Chafing point between wide open throttle tank regeneration line and engine trim cover

Topic number	LI09.10-P-064290
Version	1
Design group	09.10 Air cleaner
Date	06-16-2016
Validity	All vehicles with engine M133 up to engine no. 65252
Reason for change	
Reason for block

Verbau neues Teilepaket Regenerierung / Instruction new parts vent line

Montageanweisung / Instruction M133

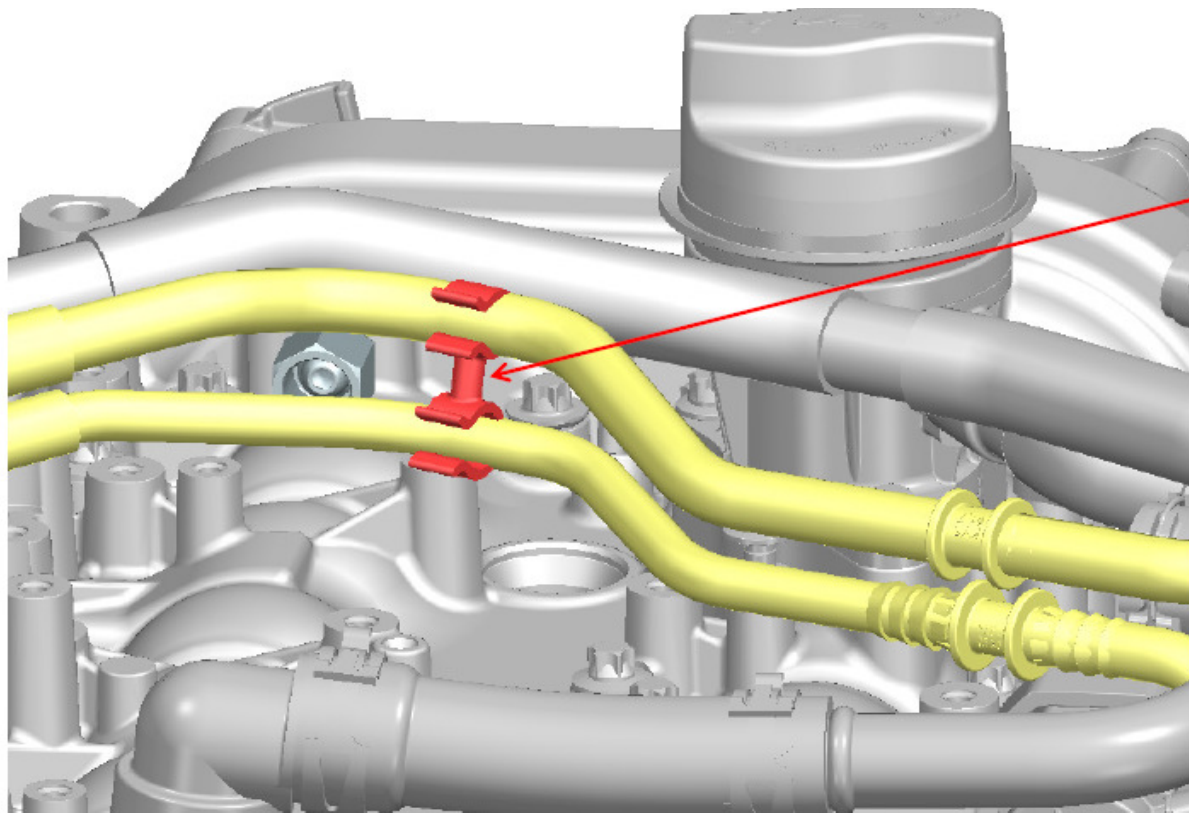
Abstandhalter zwischen den Regenerierleitungen A133 010 68 00 und 69 00 entfällt

Spacers between the new regeneration line A133 010 68 00 and 69 00 I not needed anymore

Entfall des Abstandhalter / Elimination from the
Spacer A000 995 05 75

Montageanweisung / Instruction M133

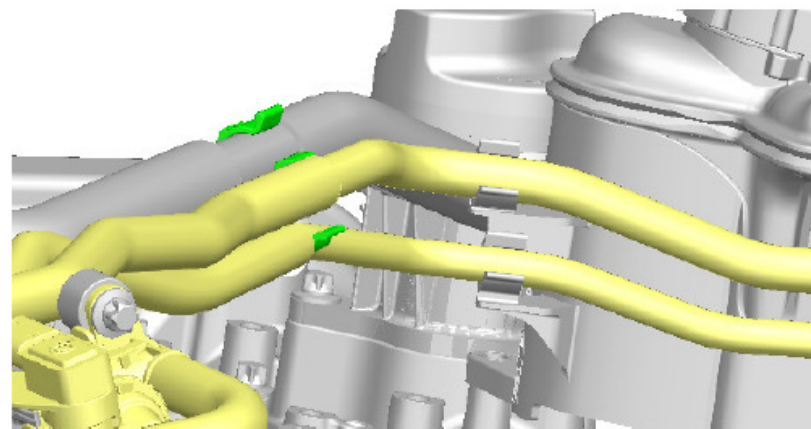
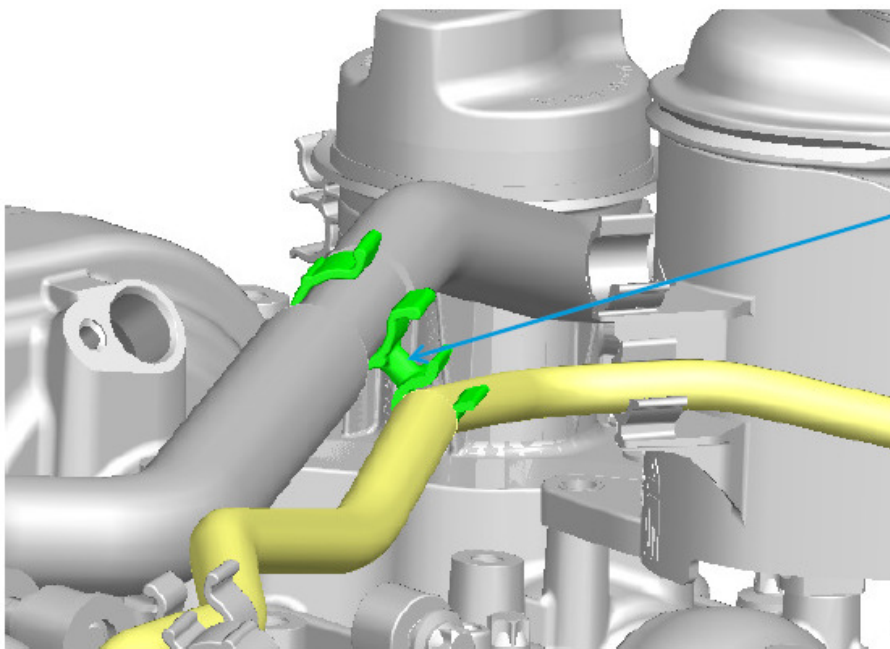
Verbleib Abstandhalter zwischen Regenerierleitung A133 010 68 00 und Entlüftungsleitung

Whereabouts spacers between the new regeneration line A133 010 68 00 and the vent

Abstandhalter A000 520 01 67 unverändert gegenüber bisherigem Verbau
Spacers A 000 520 01 67 unchanged from previous course

Montageanweisung / Instruction M133

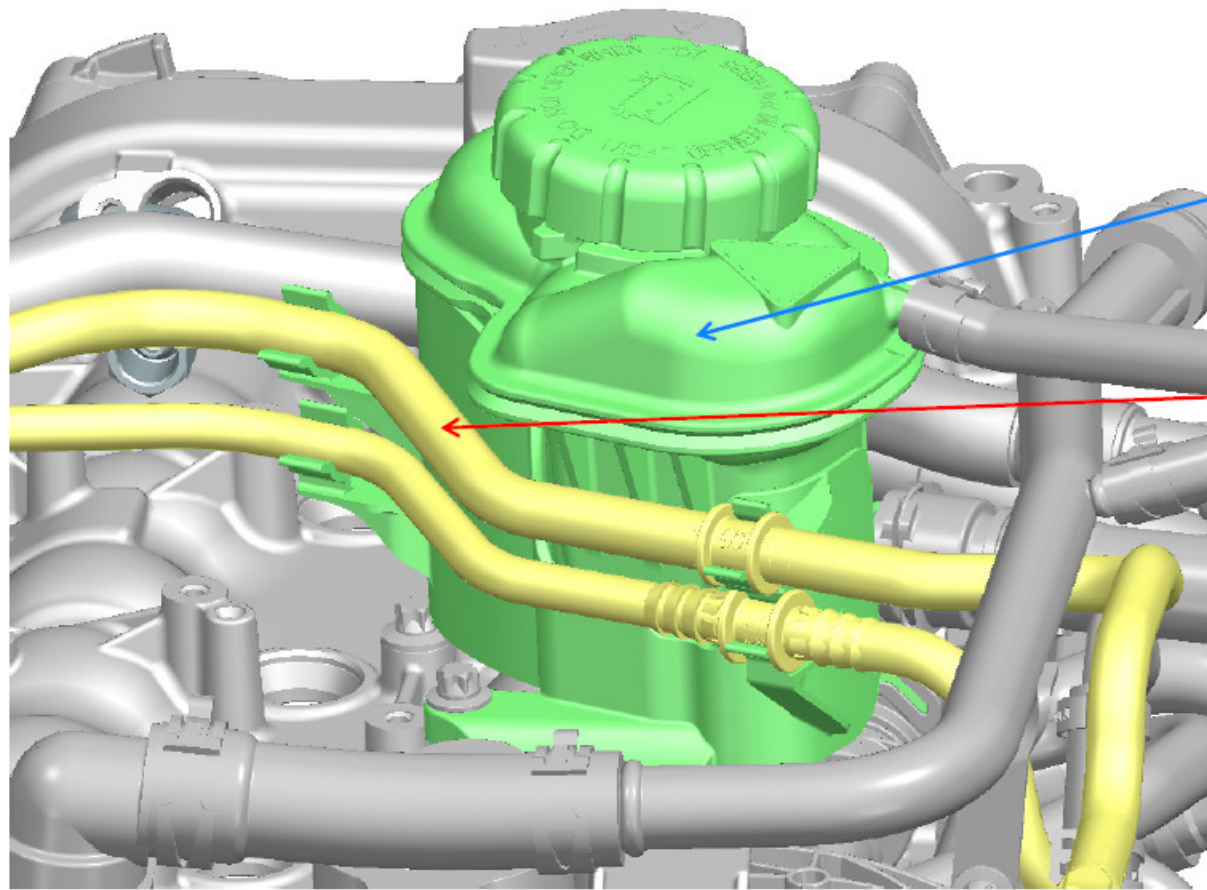
Neuer Ausgleichbehälter A133 200 00 85 und neue Regenerierleitungen A133 010 68 00 und 69 00

New cooling reservoir A133 200 00 85 and new vent lines A133 010 68 00 and 69 00

Neuer Ausgleichbehälter / New cooling reservoir A133 200 00 85

Entfall der Abstandsringe / Elimination of the rubber spacers A001 997 06 44
